**SUBMISSION WITH RESPECT TO DRAFT MAMRE ROAD PRECINCT STRUCTURE PLAN UNDER STATE ENVIRONMENTAL PLANNING POLICY (WESTERN SYDNEY EMPLOYMENT AREA) 2009 ON BEHALF OF MAMRE ROAD HOLDINGS PTY LTD AND VAPOVI PTY LTD**

On Behalf of Vapovi Pty Ltd and Mamre Road Holdings Pty Ltd, 771-781 and 783-797 Mamre Road, Kemps Creek WTJ19-561

**Re: Submission With Respect To Draft Mamre Road Precinct Structure Plan Under State Environmental Planning Policy (Western Sydney Employment Area) 2009 On Behalf Of Vapovi Pty Ltd and Mamre Road Holdings Pty Ltd**

Figure 4 - Proposed Land Reservation Acquisition and Precinct Road Alignment

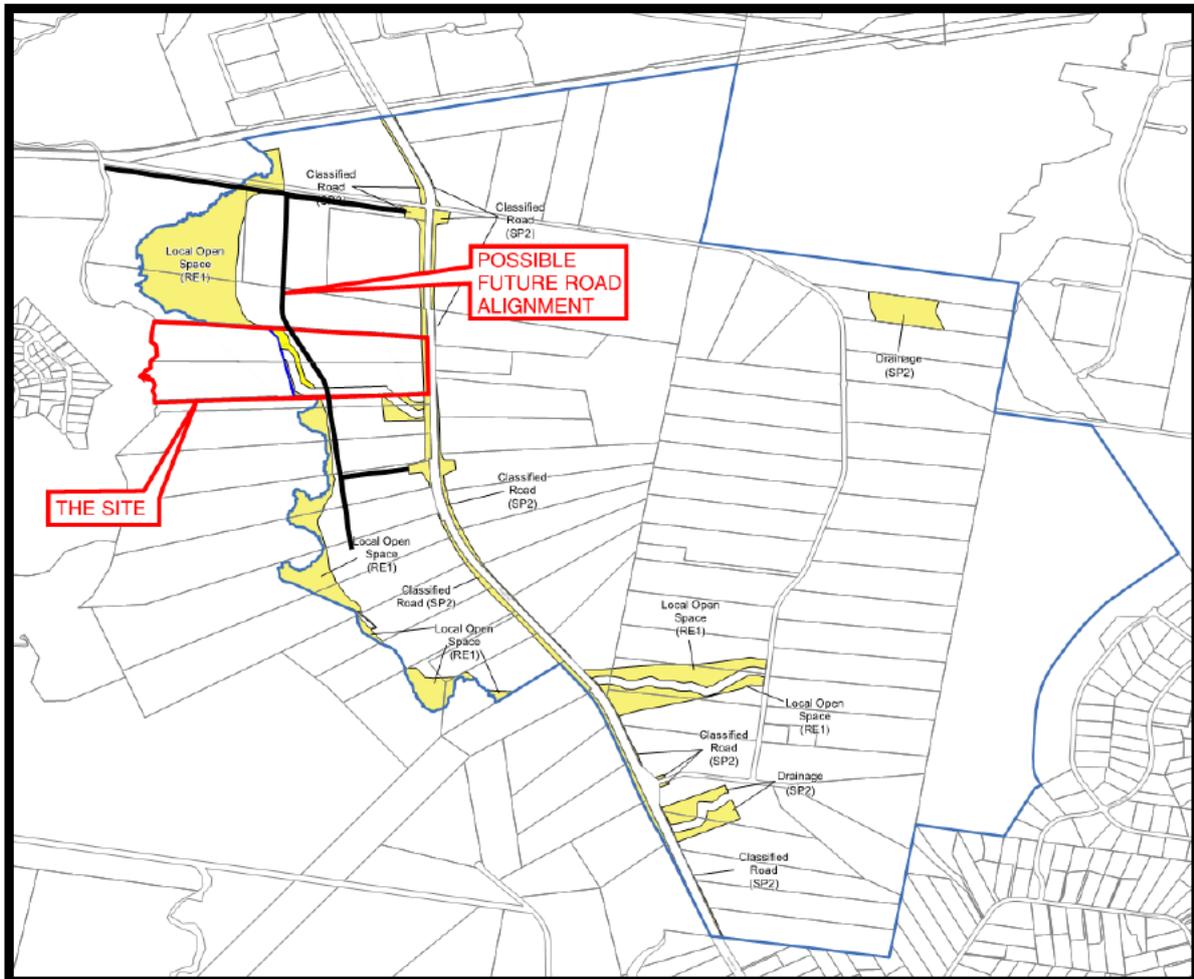
The realigned precinct boundary will also have a positive effect on any future local collector road alignment. By realigning the precinct boundary a collector road is able to be easily provided with any future road reserve linking the north and south areas of the western side of the Mamre Rd precinct. Figure 4 – Proposed Land Reservation Acquisition shows the proposed Precinct Boundary location
